# Product Change Notification

Product Change Notification: PCN-22-130620

26pos Mixed TAB HOUSING SEALED

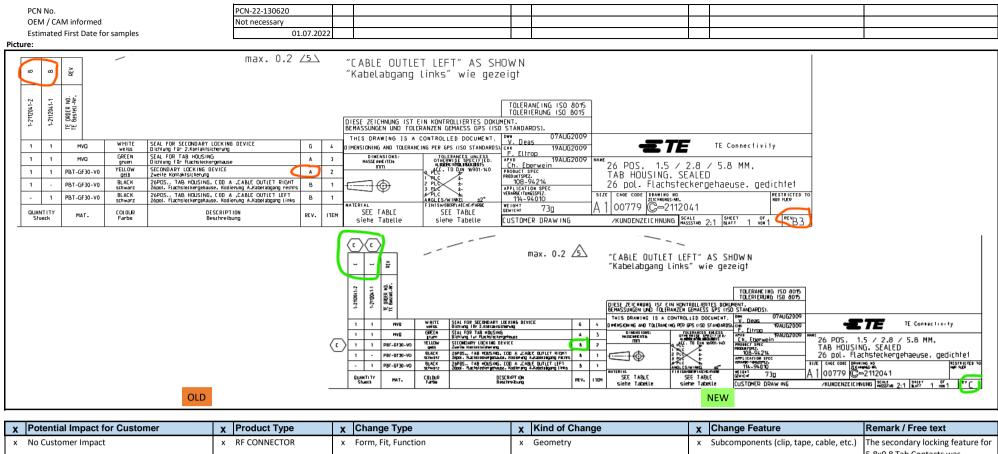
Description of Changes Please be aware of an upcoming feature change to the listed part numbers. 1-2112041-1/-2 Before: Secondary Locking Rev. A After: Improved Secondary Locking Rev. B Secondary Locking improved for 5.8x0.8mm Tab Contact regarding 6mm Cable Crimp improved Other attachments: PCN/ECR Form

Γ	x No Customer Impact	х	RF CONNECTOR	х	Form, Fit, Function	х	Geometry	х	Subcomponents (clip, tape, cable, etc.)	The secondary locking feature for
										5.8x0.8 Tab Contacts was
										improved for 6mm <sup>2</sup> cable crimps.
										There is no impact on customer
										side but an improvment in
										combination with 5.8x0.8mm
										contacts.
